PRODUCT CHANGE NOTIFICATION

PCN Number: 438

Title of Change: PCN 438 Datasheet Update for T-3 1/4 Miniature Bayonet and Screw Base

T-3 ¼ Miniature Bayonet Base

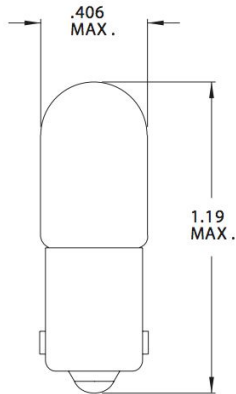
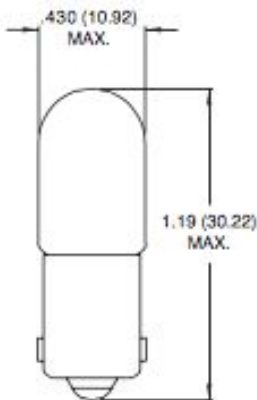
Reason of Change: Specifications for several Miniature Lamps T-3 1/4 Bayonet Base and Screw Base are updated.

Some Part Numbers were also corrected on datasheet, removing the 'CM' that was in front of a valid part number.

The last page of this Product Change Notification shows change between old and new datasheet.

Part Number	Design Voltage	Amps	MSCP	Life Hours	Filament Type
CM1826	18.0	.15	1.8	250	C-2V
CM1437	24.0	.06	.90	20	C-2F
CM1818	24.0	.17	3.3	250	C-2V
CM313	28.0	.17	3.5	500	C-2F
CM757	28.0	.08	.62	7,500	C-2F
CM1819	28.0	.04	.34	2,500	C-2F
CM1820	28.0	.10	1.6	1,000	C-2F
CM1829	28.0	.07	1.0	1,000	C-2F
CM1843	28.0	.02	.20	3,000	C-2F
CM1864	28.0	.17	3.0	1,500	C-2F
CM1873	28.0	.20	3.0	7,000	C-2F
CM1822	36.0	.10	2.1	1,000	C-2F
CM1828	37.5	.05	.65	3,000	C-2F
CM1835	55.0	.05	1.1	5,000	C-5
CM8-3995	130.0	.02	.20	2,000	C-5
CM949	130.0	.022	.40	2,000	2CC-2F

Part Number	Design Voltage	Amps	MSCP	Life Hours	Filament Type
1818	24.0	.17	3.3	250	C-2V
CM313	28.0	.17	3.5	500	C-2F
757	28.0	.08	.62	15,000	C-2F
CM1819	28.0	.04	.34	3,000	C-2F
1820	28.0	.10	1.6	1,000	C-2F
CM1829	28.0	.07	1.0	1,000	C-2F
CM1864	28.0	.17	3.0	1,500	C-2F
1822	36.0	.10	2.5	1,000	C-2F
1828	37.5	.05	.65	3,000	C-2F
CM1835	55.0	.05	1.1	5,000	C-5
8-3995	130.0	.02	.20	2,000	CC-3A
949	130.0	.022	.40	2,000	2CC-2F
